Staff Report to the Zoning Administrator

Application Number: **05-0417**

Project Description: Proposal to construct a debris wall of about 53 feet in length up to 12 feet in height. Requires a Coastal Development Permit and a Residential Development Permit to exceed the maximum 6-foot height limitation for walls within the side yard setbacks.

Subject: Review of Geotechnical Investigation by Haro, Kasunich and Associates,
Dated January 10, 2003, and March 30, 2005, Project No. SC7983, and,
Engineering **Geology** Investigation by Rogers E. Johnson and Associates,
Dated October 16, 2002; Project No. G0204-57

SECTION A-A
Scale: 1" = 10' H & V

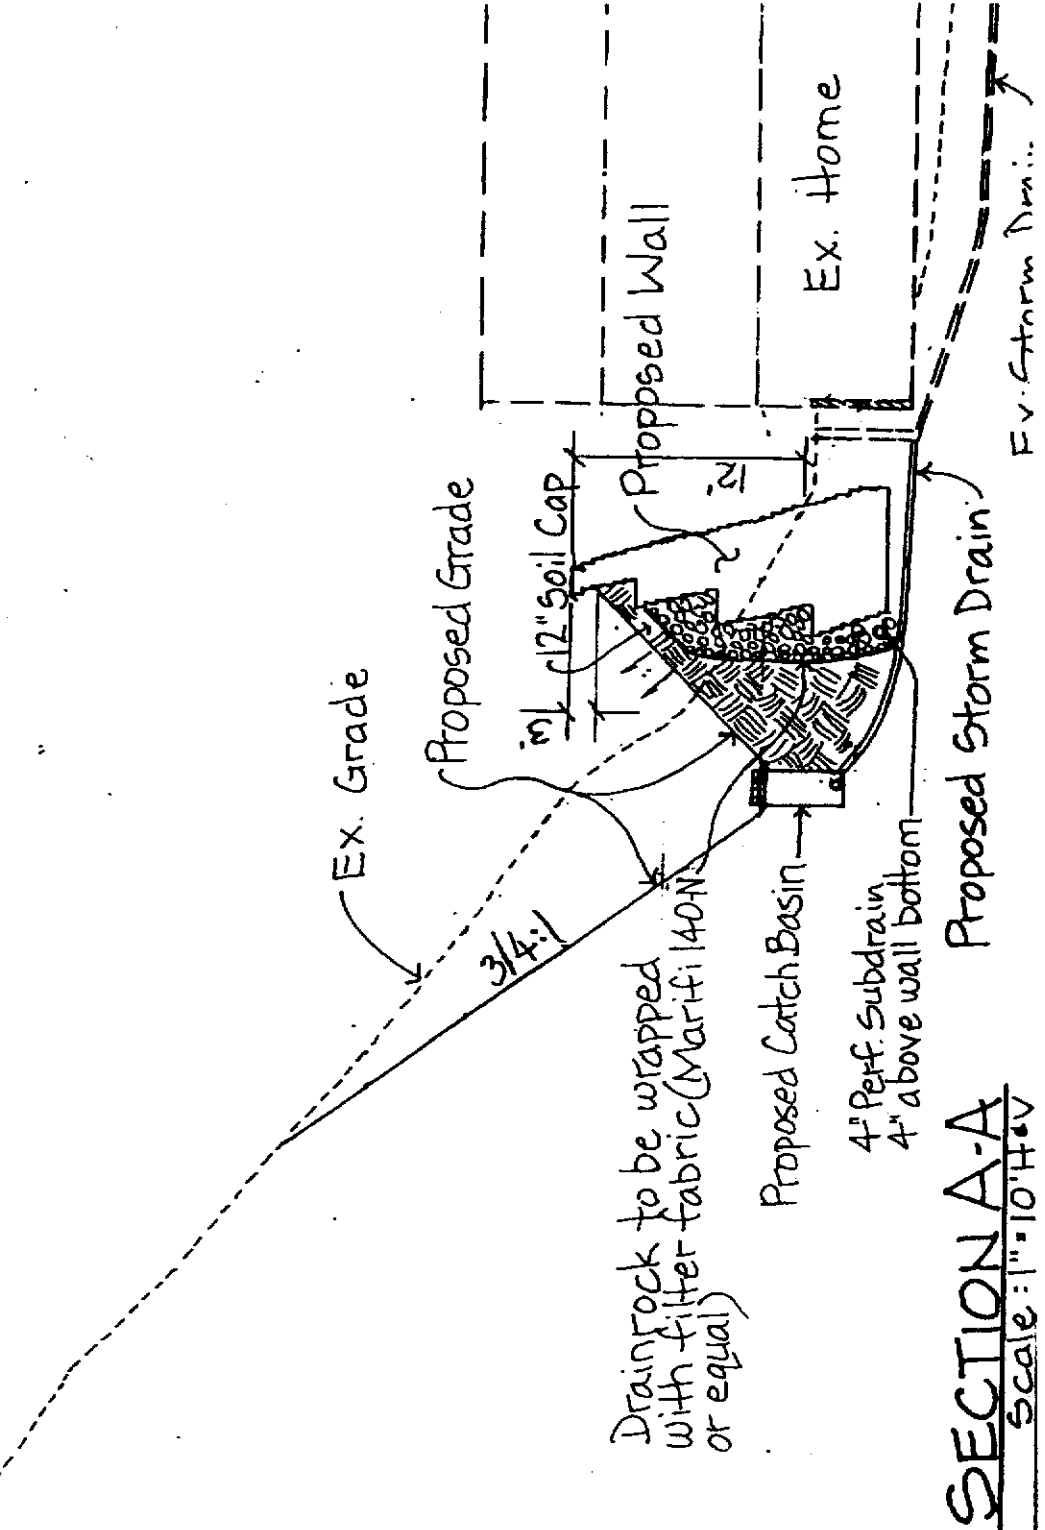
At the request of your civil engineer, Bob Milano, we have reviewed the most recent Civil Plans sent to our office by Terra Firma, dated February 2004. These plans were prepared based on geologic input by Rogers Johnson and Associates, Geotechnical input by Haro, Kasunich and Associates, and Structural Engineering by L&M Engineers. We have also reviewed the "Actual Latest Cross-Section of the Wall" sent to our office on 7 March 2005. The plans depict a debris flow barrier wall behind the Poindexter residence to protect it from potential slump sliding and debris flows which could occur on the bluff directly behind the residence. As part of our review, we discussed the final plans with Robert Milano from Terra Firma and with the project structural engineer, Brett Manning from L&M Engineering. We also discussed the review letter prepared by Rogers Johnson, Project Geologist in December 2004.

A segmented block gravity wall, with a downward 1:1 backslope, will be constructed behind the residence. The retaining wall has been designed for a 12 foot height. The 1:1 backslope acts as a protective embankment that will absorb much of the debris flow impact force. The basic requirements for the segmented block gravity wall are that its foundation is excavated into firm native materials, deep enough to eliminate surcharge loadings to the adjacent residential retaining structures and building foundation systems. The cross sectional plans indicate that this has been achieved. Portions of the base of the coastal bluff and talus material will be excavated to utilize in construction of the 1:1 impact buttress fill placed against the back of the segmented block wall. This excavation will also open up a catchment area that will allow collection of slump slide debris materials.

In summary, Rogers Johnson, project geologist, indicated if the "Actual Latest Cross-Section of the Wall" utilizes the top 3 feet (the freeboard height) to contain landslide debris, the barrier wall will have a capacity to contain 216 cubic yards of landslide material which is greater than the 165 cubic yards of landslide debris he has estimated could impact the wall. Brett Manning has indicated that the segmented wall including the top 3 foot freeboard, has been designed to contain static and dynamic loads imposed on it, by Haro, Kasunich and Associates design criteria (HKA letter dated 23 June 2004). Mr. Manning indicated he has not used passive resistant pressures in his calculation to resist sliding or overturning. Therefore the barrier wall will not add stress to the adjacent downslope retaining walls. The vertical bearing load forces of the barrier wall do not influence the adjacent retaining wall or house foundation as laid out.

Based on a review of the Terra Firma February 2004 plan and the 7 March 2005 "Actual Latest Cross-Section of the Wall" sent to us by Bob Milano of Terra Firma, recent discussions with and review of updated calculations by the project structural engineer, Brett Manning and discussions with the project geologist, Rogers Johnson, it is our opinion the debris barrier wall is in conformance to our geotechnical recommendations presented in our Limited Geotechnical Investigation, dated 10 January 2003 and supplemental letter, dated 23 June 2004. Our firm is on stand by to observe and test all
